AIR - HP COMPRESSOR STAGE 10 BLEED VALVES - INTRODUCTION OF CHEVRON SEALS AND NEW VALVE
CENTRE STEM BUSHING - CATEGORY CODE 4 - MOD.ENG-75-0054

V2500-ENG-75-0054

SB Number 75-31 (Revision 1)

**Introduction of HP10 Bleed Valve AC 69922 Mod 2 with Chevron Seal & Metal Bush in lieu and by conversion of AC69861 & AC69922 Mod 1
DUNLOP MODIFICATION E593 (Issue 2) (IAE SB V2500-ENG-75- 0054 Rev 1)**

Figure 1 Pre and Post Mod Configuration of HP10 Bleed Valve

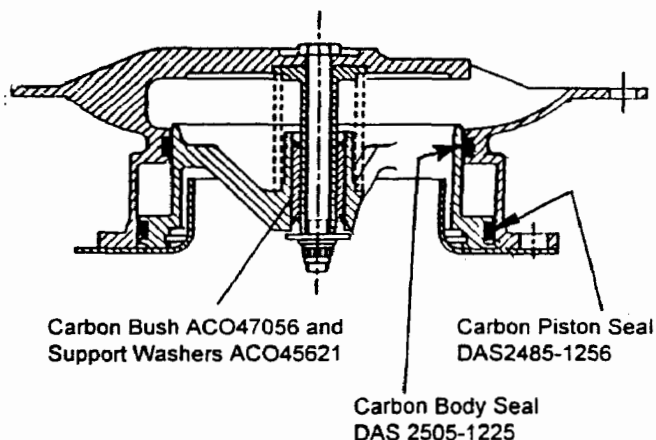
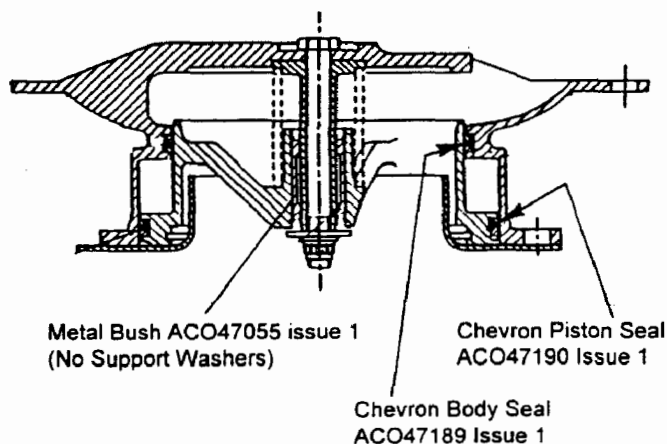
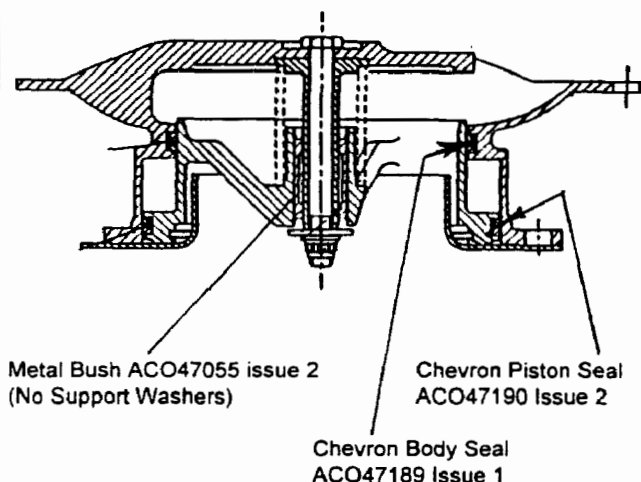
Disassembly of HP10 Bleed Valve
Replacement of Piston Triple Seal Assembly DAS2485-1256 by a new 'Chevron' Seal Assembly ACO47190 Issue 2.
Replacement of Body Triple Seal Assembly DAS2505-1225 by a new 'Chevron' Seal Assembly ACO47189 Issue 1.
Replacement of Carbon Bush ACO47056 by new Metal Bush ACO47055 Issue 2.
Renewal of Nut AS20625, Retainer MR59S and Rivet A546791
Assembly & Re-identification of the modified Bleed Valve as **AC69922 Mod 2**.

Disassembly of HP10 Bleed Valve
Replacement of Piston 'Chevron' Seal Assembly ACO47190 Issue 1 by a new 'Chevron' Seal Assembly ACO47190 Issue 2.
Replacement of Metal Bush ACO47055 Issue 1 by a new metal Bush ACO47055 Issue 2.
Renewal of Nut AS20625, Retainer MR59S and Rivet A546791
Assembly & Re-identification of the modified Bleed Valve as **AC69922 Mod 2**.

(2) Refer to figure 1 for pre and post mod configuration of the Bleed Valve

Figure 2 Exploded View of Bleed Valve P/N AC69922 Mod 2
(* Denotes Items contained in Mod Kit PN ACO47198 Issue 2)

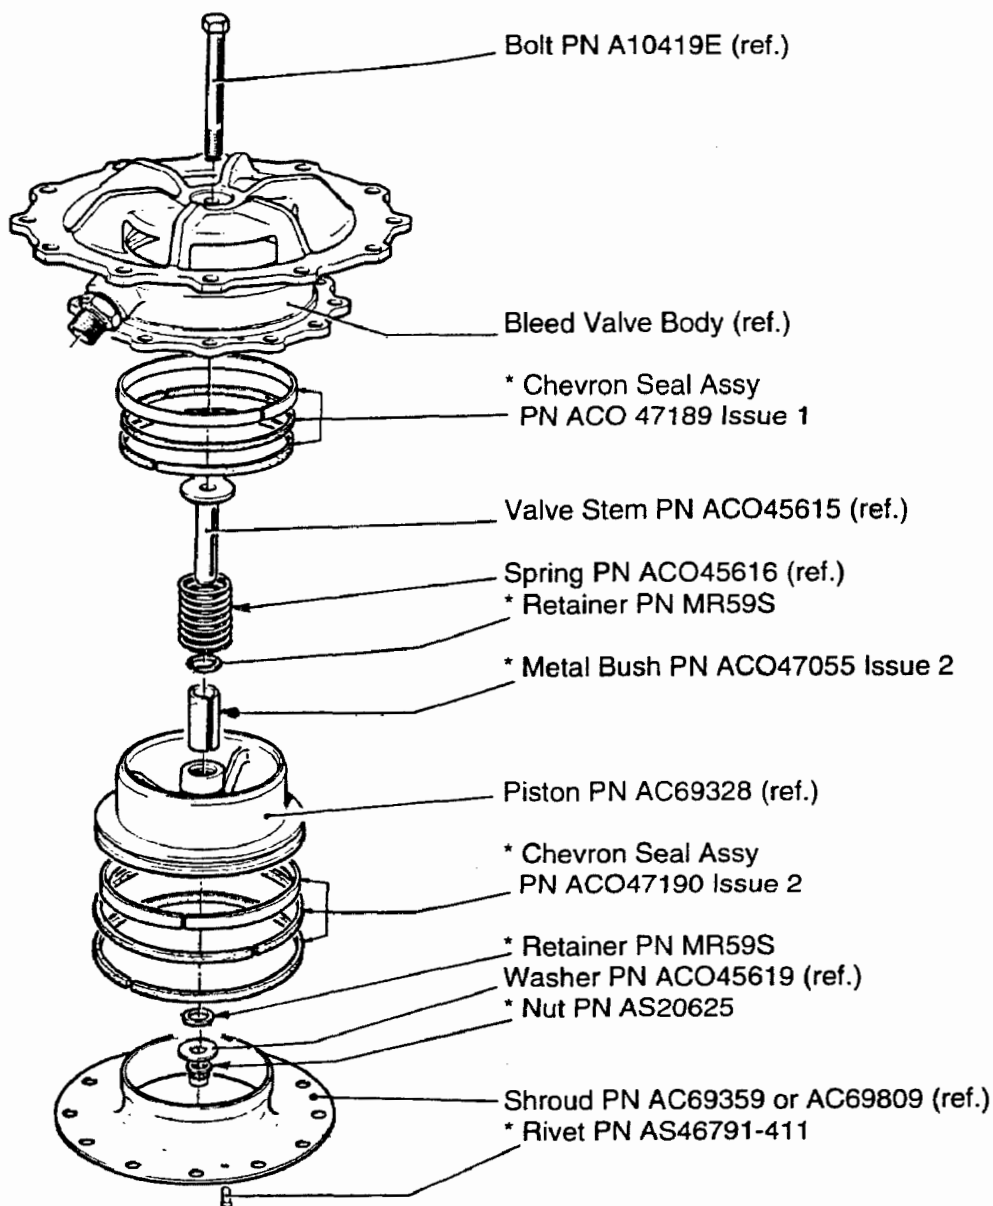
B Disassembly Instructions. (Refer to Figure 2).

- (1) Remove the two PN AS46791-411 Rivets from the PN AC69359 or PN AC69809 Shroud and remove the Shroud from the Bleed Valve Body.
- (2) Using the Britool A70, AB312 and AB437 Tools remove the PN AS20625 Nut, the PN ACO45619 Washer and the PN A10419E Bolt. Discard the PN AS20625 Nut.
- (3) Remove the PN AC69328 Piston complete with the PN ACO45615 Valve Stem and PN ACO45616 Spring.

- (4a) Remove the PN DAS2485-1256 Carbon Triple Seal Assembly from the Piston. Discard the PN DAS2485-1256 Carbon Triple Seal Assembly
- (5a) Remove the (two off) PN MR59S Retainers, the (two off) PN ACO45621 Washers and the PN ACO47056 Carbon Bush from the Piston. Discard the PN ACO45621 Washers, the PN MR59S Retainers and the PN ACO470 Carbon Bush.
- (6a) Remove the PN DAS2505-1225 Carbon Triple Seal Assembly from the Bleed Valve Body. Discard the PN DAS2505-1225 Carbon Triple Seal Assembly.

- (4a) Remove the PN ACO47190 Issue 1 Chevron Seal Assembly from the Piston. Discard the PN ACO47190 Issue 1 Chevron Seal Assembly
- (5b) Remove the (two off) PN MR59S Retainers and the PN ACO47055 Issue 1 Metal Bush from the Piston. Discard the PN MR59S Retainers and the PN ACO47055 Issue 1 Metal Bush.
- (6b) No further disassembly is required. **Do Not Remove** the PN ACO47189 Issue 1 Chevron Seal Assembly from the Body unless it is unserviceable.

D Fitment Instructions. (Refer to Figure 2)

- (1) Install a new PN ACO47189 Issue 1 Chevron design carbon / nimonic Triple Seal Assembly in the Bleed Valve Body.
Make sure the ring gaps are equispaced around the circumference.

- (2) Install one of the replacement PN MR59S Retainers and the new PN ACO47055 Issue 2 metal Bush in the Piston.
- (3) Install a second replacement PN MR59S Retainer in the Piston.

- (6) Install the PN ACO45616 Spring on the Valve Stem.
- (7) Install a new PN ACO47190 Issue 2 Chevron design carbon / nimonic Triple Seal Assembly on the PN AC69328 Piston.
Make sure the ring gaps are equispaced around the circumference

- (12) Using the Acratork Model A, Britool AB312 and AB437 Tools torque tighten the PN AS20625 Nut to 8,5/9,0 Nm (75/80 lbf in.) plus the torque required to overcome the lock properties of the Nut.
